Application for Works Approval

Works Approval Number	W6621/2021/1
Applicant	Asphaltech Pty Ltd
ACN	064 520 869
File number	DER2021/000589
Premises	Asphaltech Picton 2 Sutherland Way PICTON WA 6229 Legal description Part of Lot 55 on Diagram 22200 Certificate of Title Volume 2119 Folio 623 As defined by the coordinates in Schedule 2 of the works approval Shown on the premises map attached to the works approval
Date of report	8 March 2022
Decision	Works approval granted

3.2 Figure 1: Distance to human receptors Air emissions screening and modelling

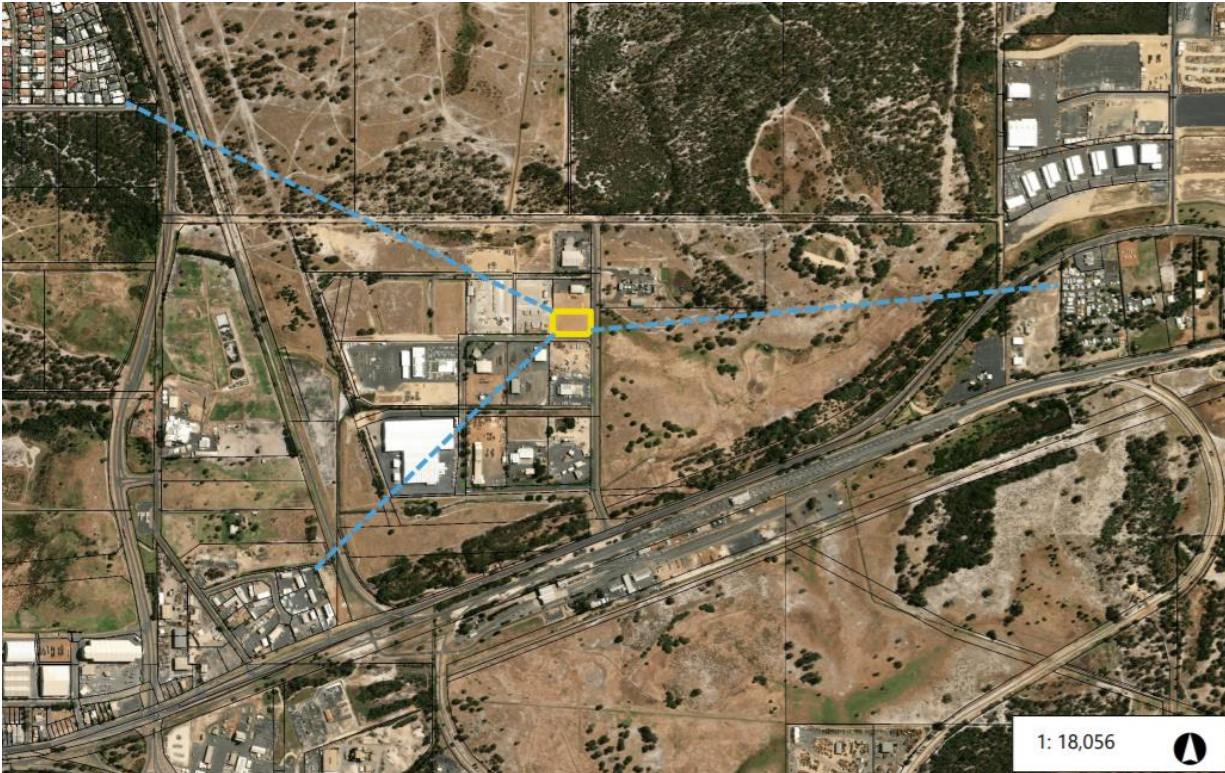
Table 2 and Figure 1 below provides a summary of potential human and environmental receptors that may be impacted as a result of activities upon or emission and discharges from the prescribed premises (*Guideline: Environmental Siting* (DWER 2020)).

Figure 2: Results of noise screening assessment

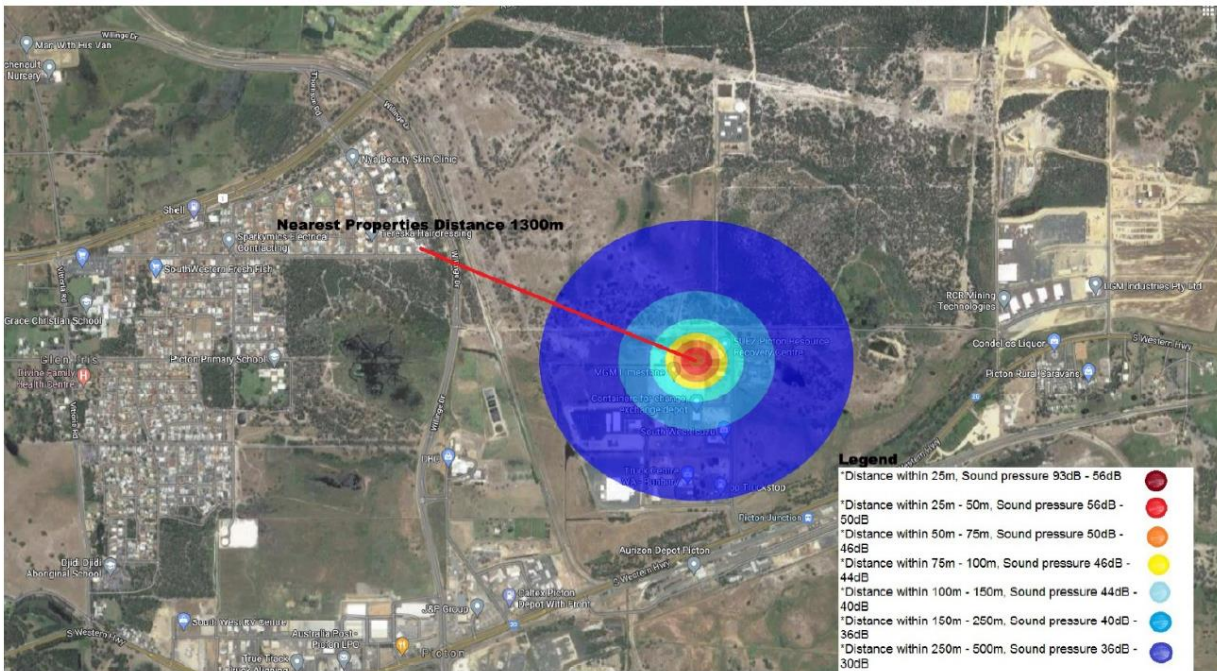
The predicted noise impact, as a direct sound propagation calculation without barriers or reduction of vegetation, at the nearest sensitive residential receptor is 21.82 dB, which is well below the assigned noise level at nighttime for these premises (set at 35 dB as LA_{10}). See Figure 2 for the screened potential noise impacts from the Premises.

The Delegated Officer conducted a similar sound propagation calculation where the sound power level of a front-end loader was used of 105 dB. The predicted noise impact at 1300m would then be 33.9 dB, which is still below the assigned noise level for the residential premises.

Predicted impact on neighboring industries and commercial premises is expected to meet the assigned noise level of 65 dB (LA_{10}) with a predicted noise impact beyond 25m from the equipment to be less than 56dB as can be seen in Figure 2.
